JRPP No:	2010SYE0107
DA No:	DA494/10
PROPOSED DEVELOPMENT	Demolish existing buildings and construct a multi storey mixed use building comprising 2 levels of commercial space, 48 apartments, basement parking at No.12-16 Berry Street, North Sydney
APPLICANT:	Benson McCormack Architects
REPORT BY:	Geoff Mossemenear, Executive Planner, North Sydney Council

Assessment Report and Recommendation

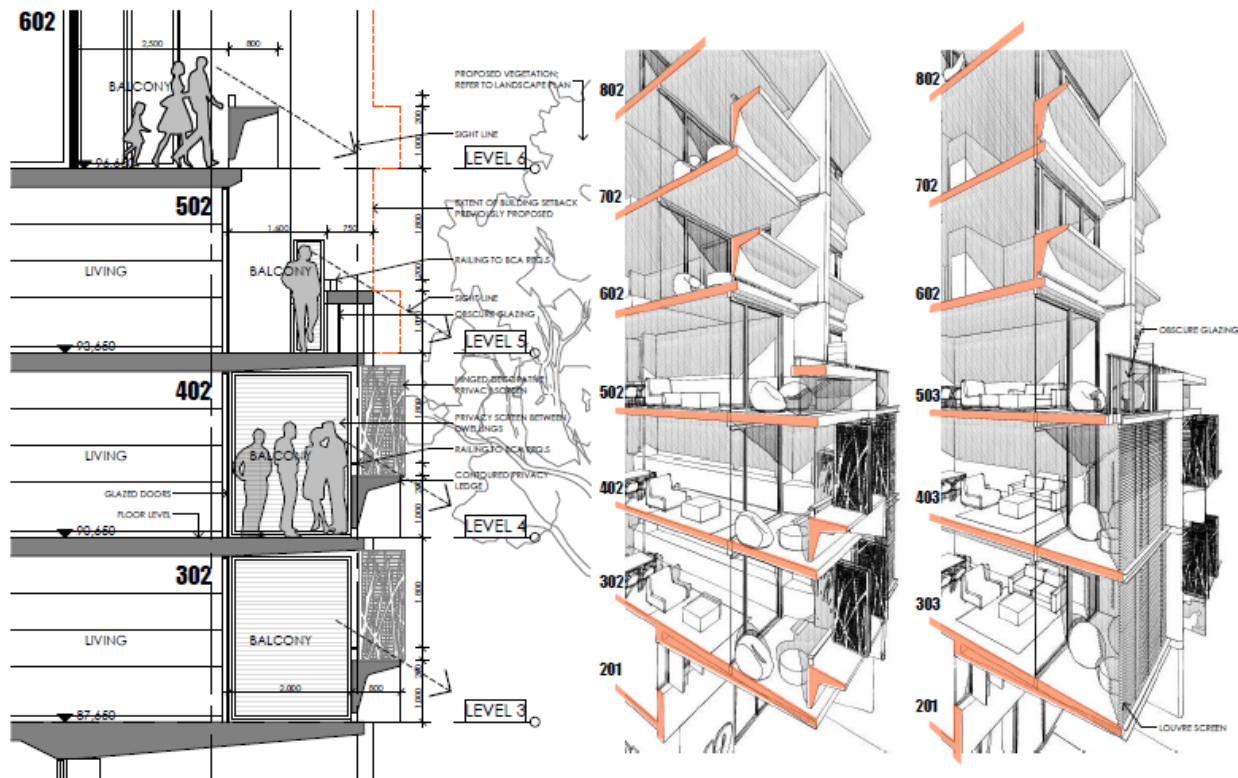
The proposed development incorporates a suitable mix of commercial and residential uses. The building steps down slightly in height as it approaches its residential interface to the north of the site and the overall height could now be regarded as more compatible with the adjoining residential area provided the separation distance of the upper levels is appropriate. It is considered that the amended setbacks of levels 6 and 7 to a minimum of 9m from the boundary and the balcony at level 8 being setback an additional 2m making an 11m setback from the northern boundary is acceptable. Although the northern walls of those upper levels are all in breach of the building height plane, these more appropriate setbacks assist in ensuring compatibility.

Building Height Plane Controls

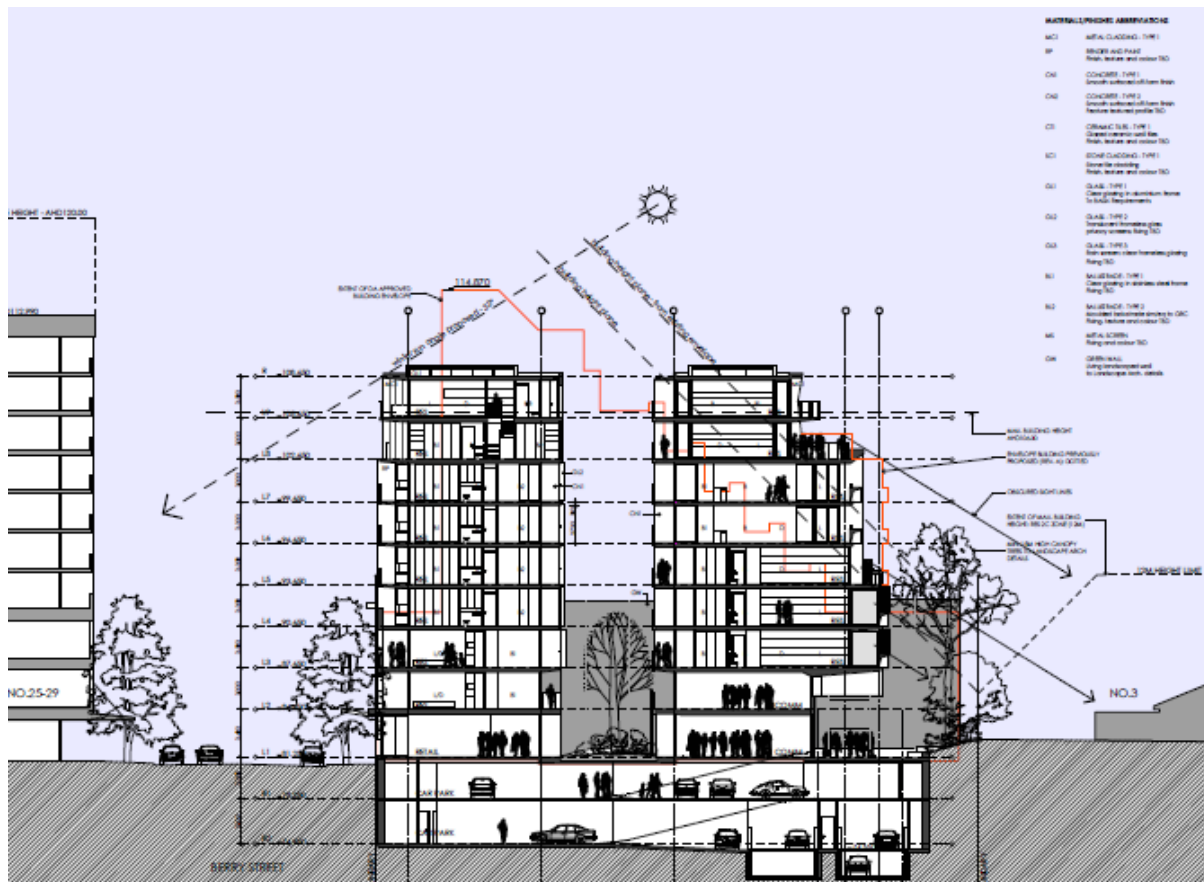
The proposed development is considered to be compatible with the amended setbacks of the upper levels from the residential zone to the north. By providing setbacks more in line with SEPP 65 for the building above 12m in height, the bulk and scale has become more compatible when viewed from the adjoining rear yards. The increase in the building separation by 2m assists in reducing adverse effects on neighbouring properties. The modification also results in a more acceptable density and dwelling mix on the site.

The breach of the building height plane occurs above level 4. The building would appear as a 7 storey building from the adjoining rear yards from the boundary. The amended setbacks have increased the separation above the 4th storey to be consistent with SEPP 65 setbacks. This is considered to be compatible with the adjoining Residential C zone (maximum height of 12m) and will ensure that adverse effects are minimised in relation to building separation.

The SEPP 1 objection with regard to the building height plane control is considered to be well founded under the circumstances of the subject site and can be supported.
